Access Compliance Report Public Rights-of-Way (Curb Ramps)

Intersection ID: 18245 Main Street: HASSELL_PL Cross Street: SELWYN_AV Location: SE

ADA ID: D90A782F0BCB Ramp Type: PerpDiag Initial Pass/Fail: Fail Overall Compliance: No Severity Score: 8.75

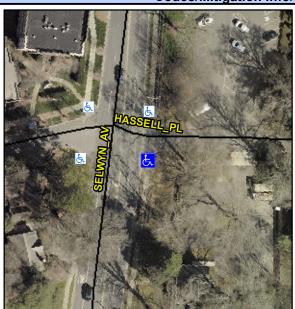
Not Found, R304.5.1

Field Measurements/Component Compliance						
	Compliance Description		Data	Compliance Description		Data
	N/A	Ramp Length (in)	36.0	Yes	Ramp Slope (%)	6.6
	No	Ramp Width (in)	38.0	Yes	Ramp XSlope (%)	0.3
	N/A	Flare Type LT	N/A	N/A	Flare Type RT	N/A
	N/A	Flare Slope LT (%)	N/A	N/A	Flare Slope RT (%)	N/A
	N/A	Flare Traversable LT?	N/A	N/A	Flare Traversable RT?	N/A
	N/A	Landing Length (in)	N/A	N/A	DWS Provided?	N/A
	N/A	Landing Width (in)	N/A	N/A	DWS Contrast?	N/A
	N/A	Landing Slope (%)	N/A	N/A	DWS Length (in)	N/A
	N/A	Landing X Slope (%)	N/A	N/A	DWS Full Width?	N/A
	N/A	Landing Curb? (Y/N)	N/A	N/A	DWS Offset (in)	N/A
	N/A	Shared Landing?	N/A			
	N/A	Gutter Ponding?	N/A	N/A	Gutter Slope (%)	N/A
	N/A	Gutter Lip Ht (in)	N/A	N/A	Gutter X Slope (%)	N/A
	N/A	Painted X Walk1?	No	N/A	Painted X Walk2?	No
		X Walk 1 Direction	To N		X Walk 2 Direction	To W
	N/A	X Walk 1 Width (in)	N/A	N/A	X Walk 2 Width (in)	N/A
		X Walk 1 Slope (%)	0.2		X Walk 2 Slope (%)	1.5

Remove & Replace Curb Ramp With
Two New Directional Ramps or
Equivalent.
